SUBMISSION FOR APPLICATION No. SSD5752

Please find the submission below that OBJECTS to the current Development Application SSD5752.

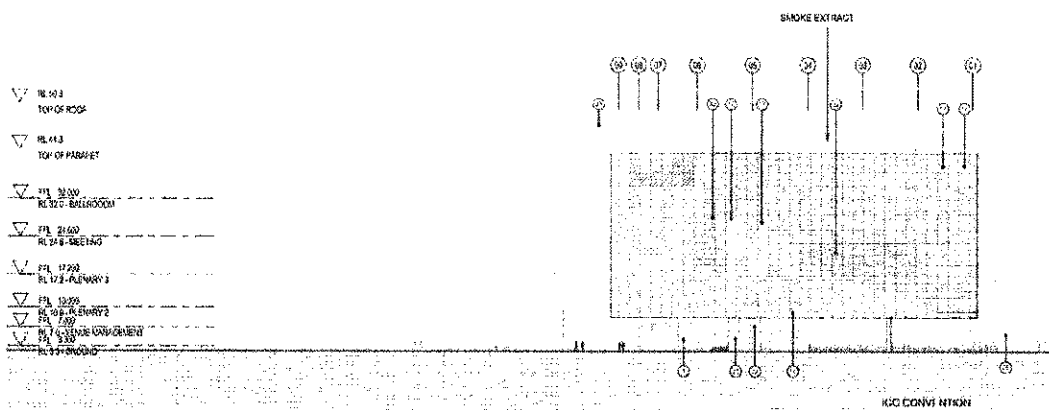
We firstly object to the height of the proposed new ICC convention centre which is nearly to the top of the Goldsbrough's current height.

In the DA plans the proposed height is RL 50.3 which will block the entire view to Darling Harbour and the city from the Goldsbrough's eastern facing apartments. There is supposed to be a concept of view sharing in the city but in this case the whole of the eastern view of the Goldsbrough will be blocked out by the new ICC convention centre.

In place of the current city skyline and Darling Harbour view there will be a flat blank metallic wall in its place, which is the rear of the proposed ICC convention building. The front of the ICC building looks to be nicely designed with glass and is broken up in angles, but the Goldsbrough will be facing an ugly flat back wall made of aluminum and mainly Grey.

Please see the diagram of the back of the ICC convention centre below , which will be approximately the same height as the Goldsbrough.

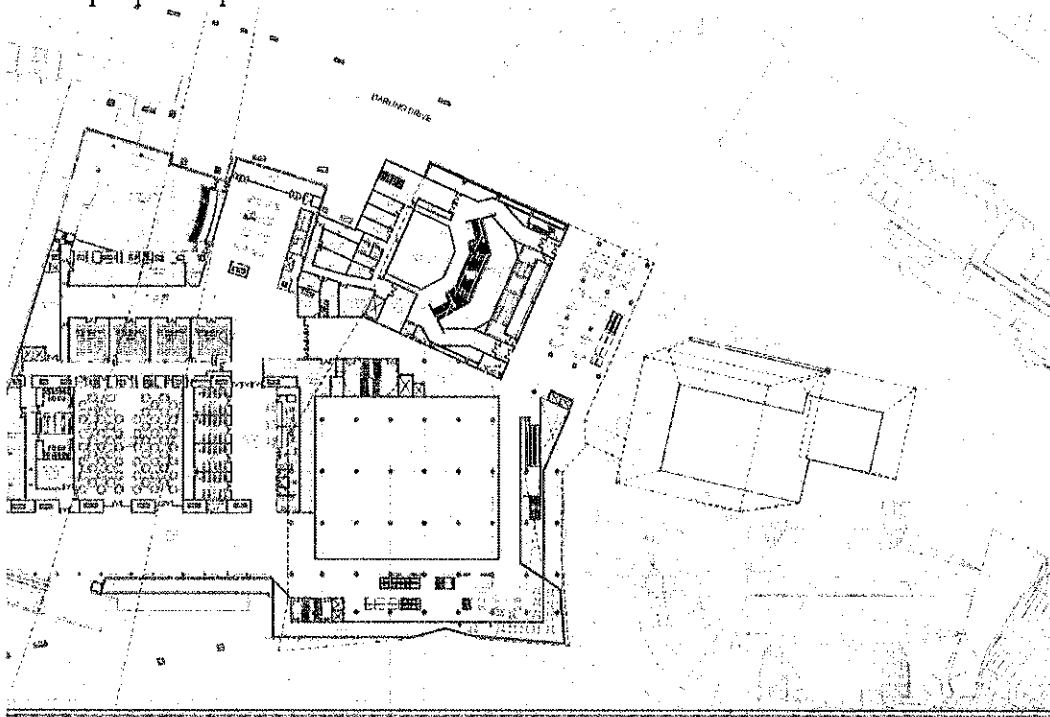
The proposed changes at Darling Harbour seem to take away an extremely important thoroughfare for the residents and guests of the Goldsbrough. From the plans it looks like the current overhead pedestrian walkway next to the Convention monorail station is being removed. Currently it is the easiest and safest walkway to enter the Darling Harbour precinct from the Western side.

From the Architectural drawings below it shows how the current walkway is removed in the proposed plan

This is the walkway being removed

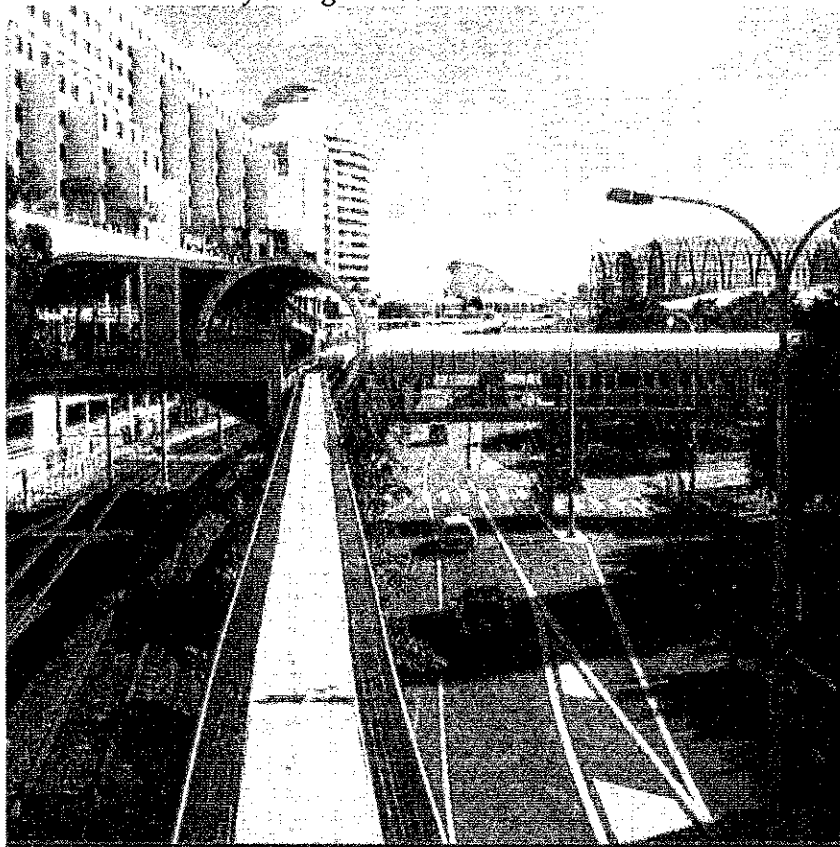
If this entry to Darling Harbour is removed it will be a total disaster for many of the pedestrians who regularly use it as well as visitors to the area. Currently it is estimated that there are around 7000 pedestrian traffic movements across this walkway on a regular day and many more on busy event days. It is the only safe way to cross the light rail tracks and Darling Drive and is the direct access for 2 major car parks servicing Darling Harbour. This walkway is open 24 hours a day, 7 days a week with continuous public access.

The alternative link from the Western Distributor is not a convenient alternative to what is currently there. How are pedestrians especially with children meant to cross to and from Darling Harbour in a safe way at all hours ?

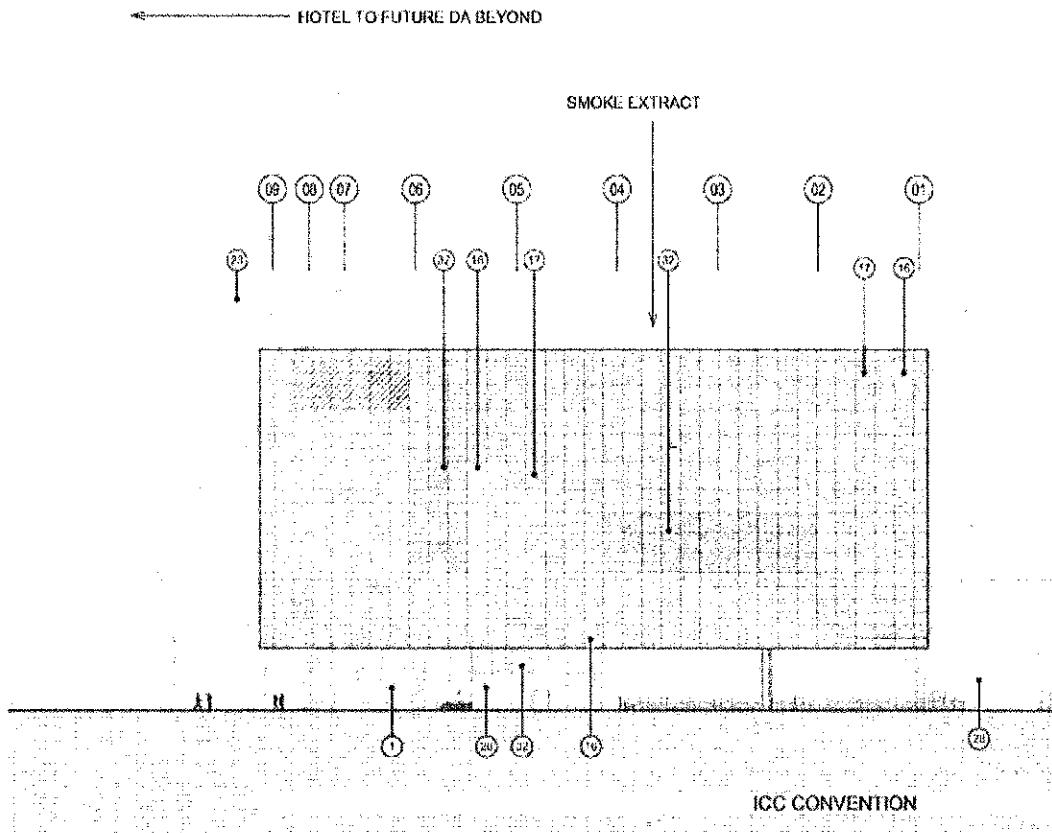
In the DA plans it shows that this will be a mainly Grey metal panel wall which will just look like a Grey metal barricade from the Goldsbrough. All the architecturally appealing glass frontage is kept for the Eastern (Darling Harbour facing) face of the building. All the publicity shots show the view of the East face yet all the Goldsbrough will see is the ugly utilitarian Western face.

If the view from the Goldsbrough is to be dominated by the ICC then at least some regard should be paid to the fact and the Western face of the ICC modified to be more aesthetically appealing. The western face could be architecturally articulated and made of materials that don't look like a metal barricade.

See Diagram below for view of the Western face of the ICC facing the Goldsbrough. Note the scale of this wall in relation to the people in the picture.

Measures such as changing the form and materials of this Western wall should be urgently considered. With a different use of materials, reshaping and clever use of lighting, this face need not be such an eyesore that will dominate most of the resident's views.

Current view of the Goldsbrough from Darling Harbour

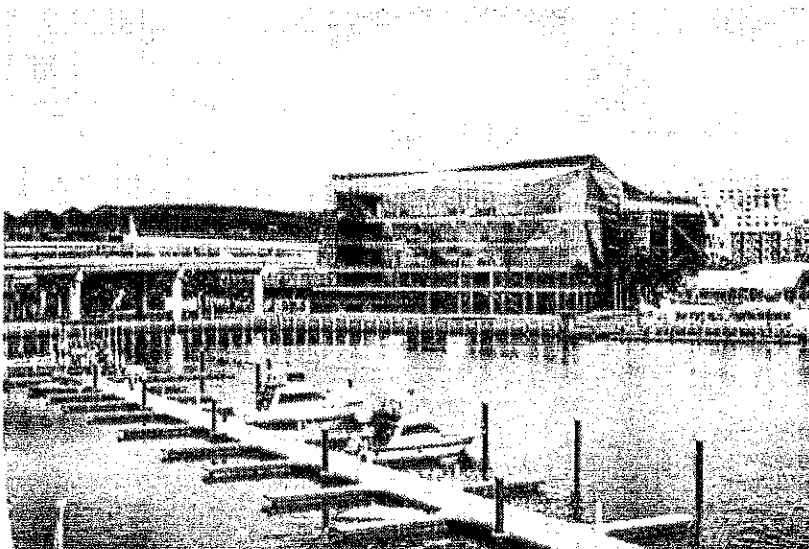
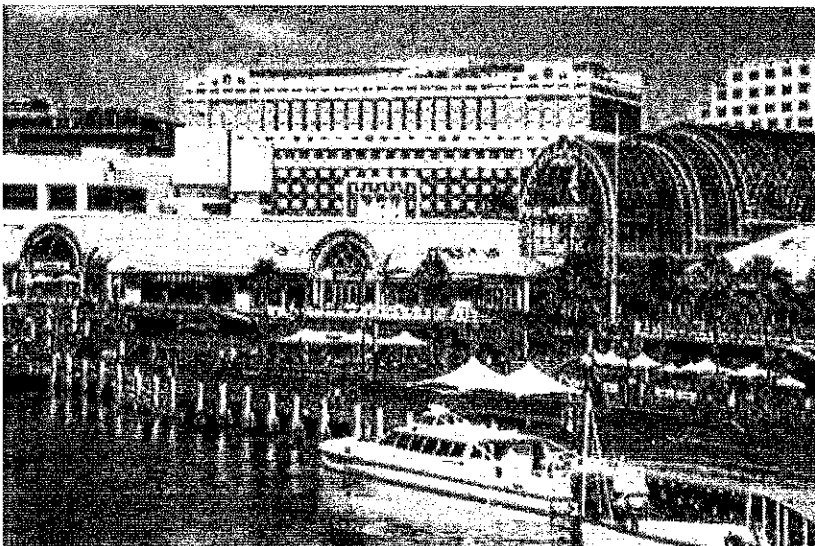
The new ICC will obscure the historic façade of the building from public view and one that has been part of the Darling Harbour landscape since Sydney's early days.

See view below of the face of the Goldsbrough being obscured by the proposed ICC.
